DESIGNED <i>PJO</i>	REVISED - ADDENDUM A 02/20/2013	STATE OF ILLINOIS DEPARTMENT OF TRANSPORTATION	EXISTING DRAINAGE PLAN - ILLINOIS ROUTE 59		F.A.P. RTE.	SECTION	COUNTY	TOTAL SHEETS	SHEET NO.	
DRAWN <i>KES</i>	REVISED -		SCALE: AS SHOWN	SHEET NO. 3 OF 15 SHEETS	STA. 3928+00 TO STA. 3942+00	338	(112 & 113) WRS-7	DUPAGE	1156	454
CHECKED <i>JCM</i>	REVISED -					DE-03		CONTRACT NO. 60R30		
DATE <i>12/14/2012</i>	REVISED -					ILLINOIS FED. AID PROJECT

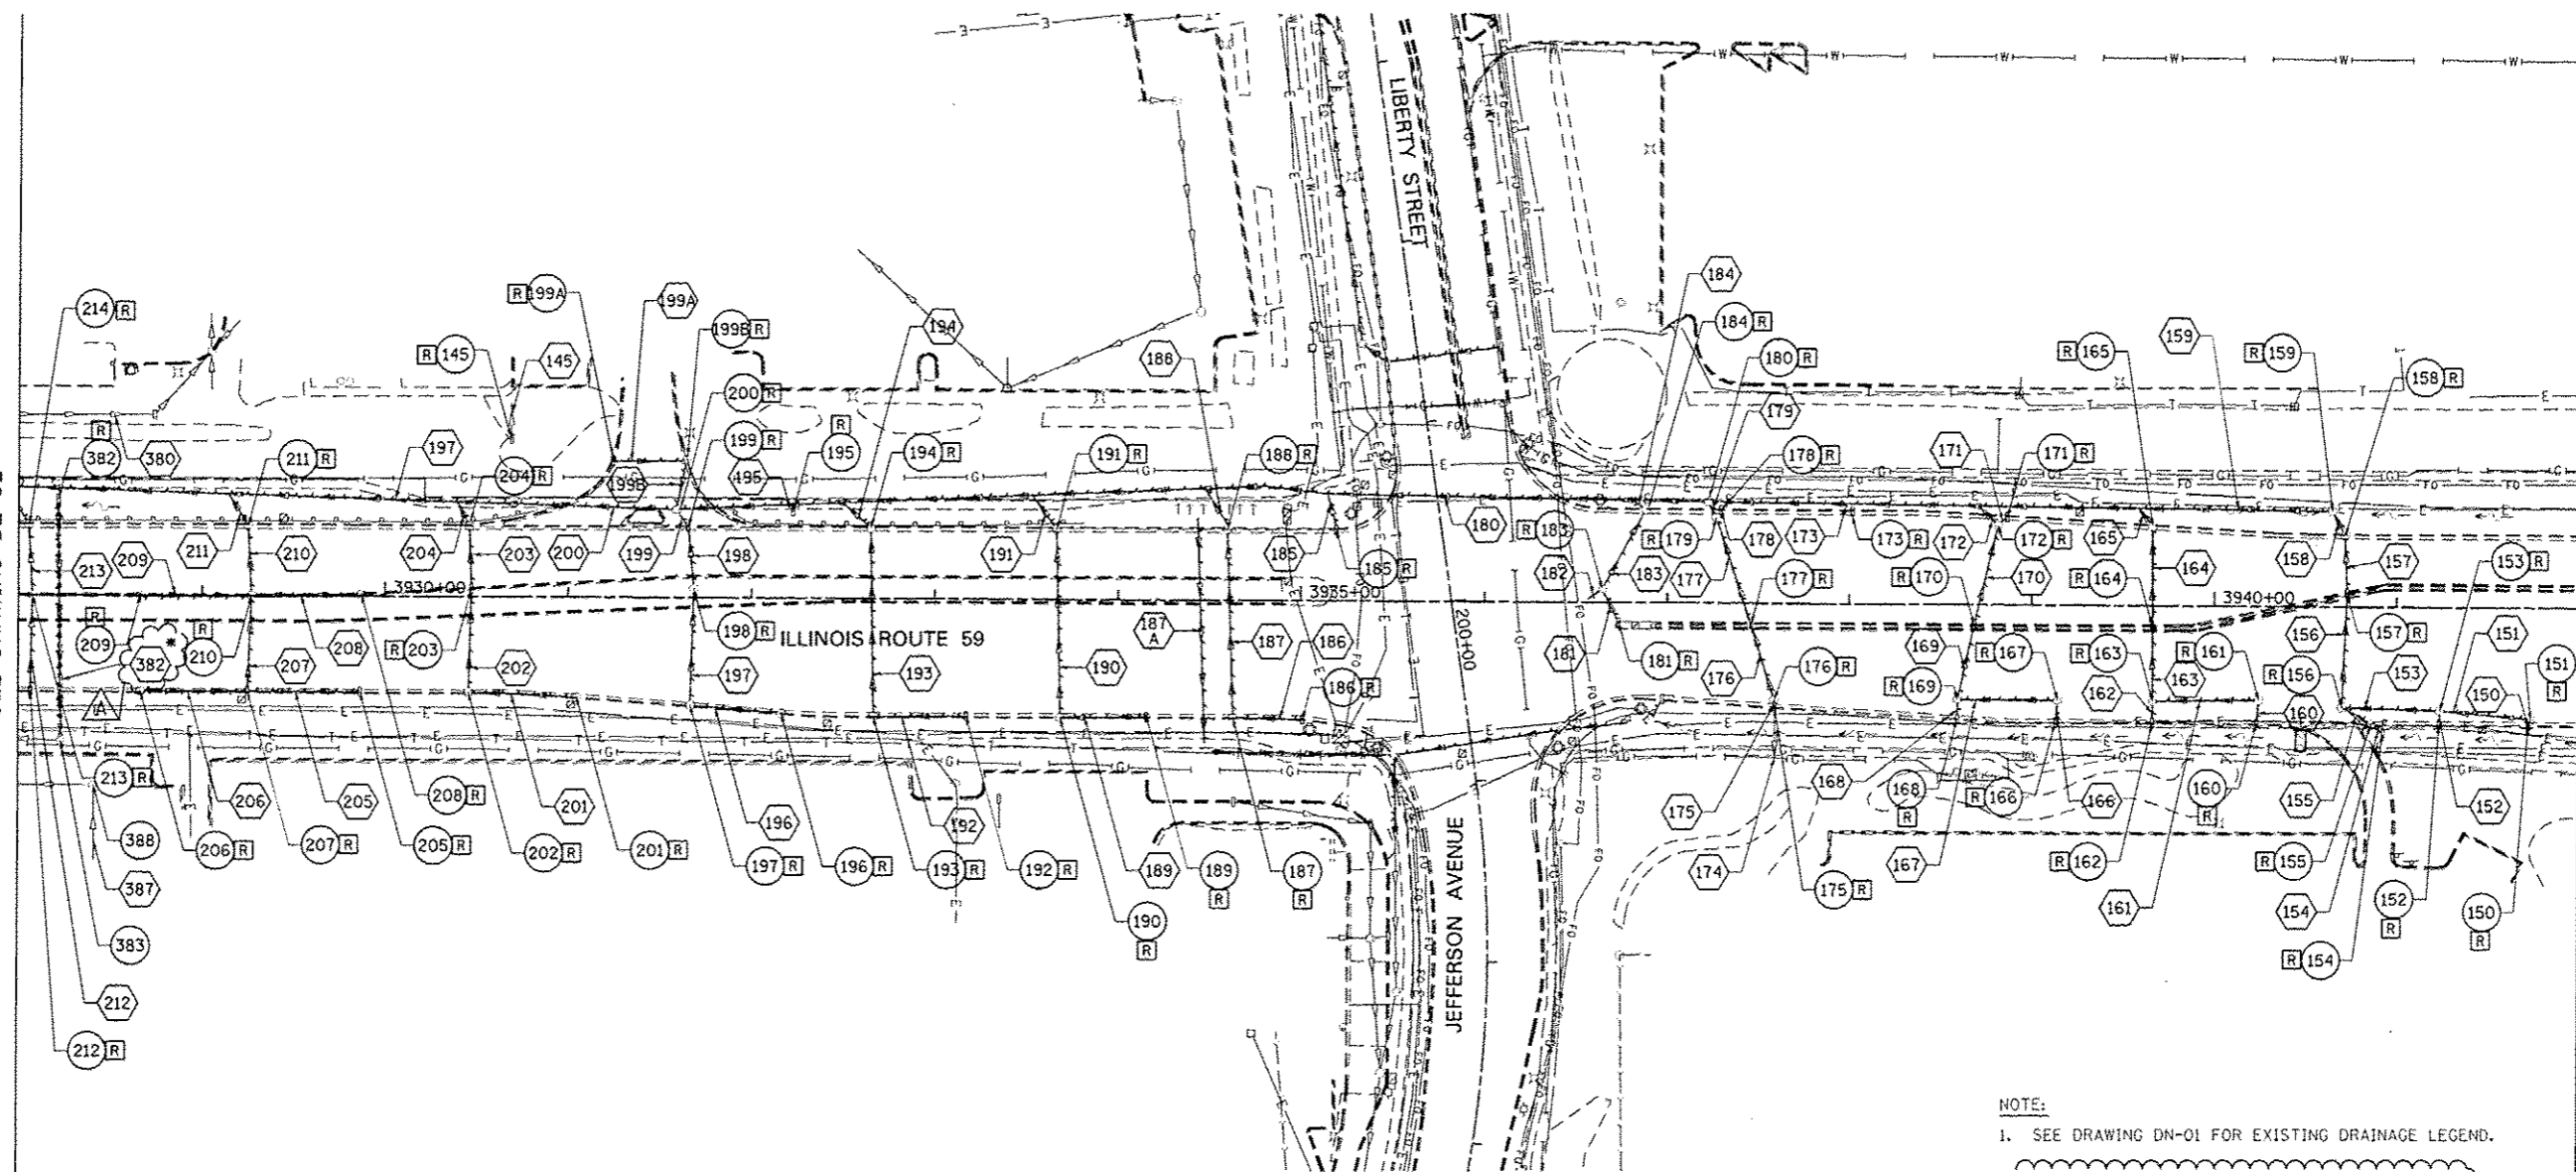
* REMOVAL OF EXISTING STRUCTURES NO. 4
